Subject: Review of U.S. EPA's Superfund Proposed Plan

LCP Chemicals Georgia Superfund Site

Operable Unit 3 – Upland Soil

ATSDR's One-half-acre parcels with Elevated Levels of Contamination at LCP Chemicals Georgia Superfund Site. Source: ATDSR April 2014 Public Health Assessment, Figure 46

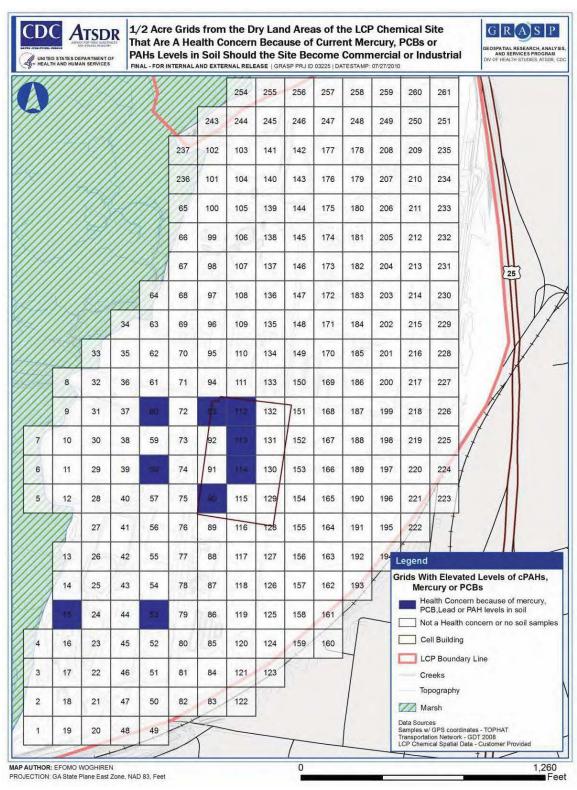
ATSDR identified "hot spots" – localized areas of higher residual PCBs, mercury, and/or cPAHs in soil – at nine, one-half-acre parcels that could harm the health of future commercial and/or industrial workers (see ATSDR map of hot spots on the next page).

While some of these hot spots are in the cell buildings area, which EPA is excluding from this action, others are located beyond that area. The elevated levels of contamination at the locations cited by ATSDR that are not in the cell buildings area are shown in the following table (ATSDR location grid numbers shown on map on previous page).

ATSDR Inadequately Sampled Areas for Determining Risk from Residual PCB Soil Contamination. Source: ATSDR April 2014 Public Health Assessment, Figure 22

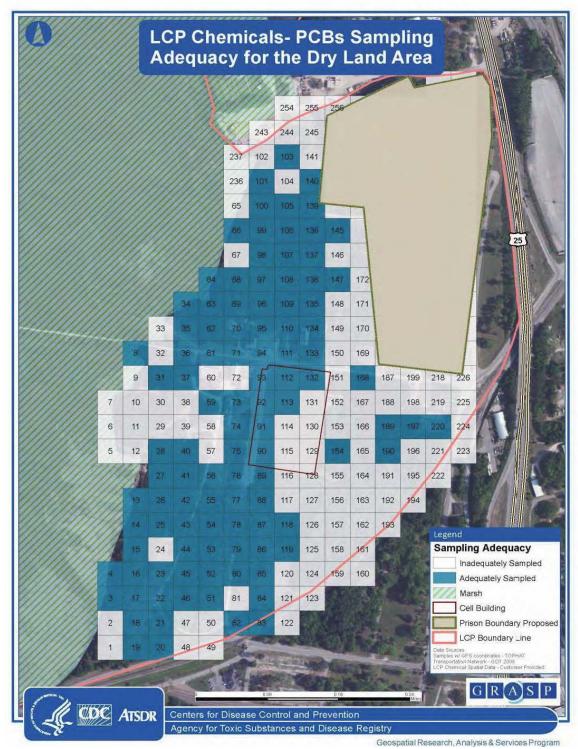
- Soil sampling was inadequate over approximately one-half of the site (see ATSDR Figures 22-25); those parts of the site require additional sampling in order to be sure that those areas are not contaminated (for example, see the ATSDR map for inadequate sampling for PCBs on the following page).
- Restricting some areas from commercial or industrial use is recommended, unless
 further steps are taken to prevent contact with PCB, mercury, and PAH
 contamination that remains in soil on the property.
- Additional soil sampling is recommended in and around the former cell buildings' footprint because of residual soil contamination if future plans include development of this area.

Additional sampling is recommended in areas where sampling data are limited, with particular attention given to the former cell buildings area, and to future enclosed structures built above the caustic brine pool area.
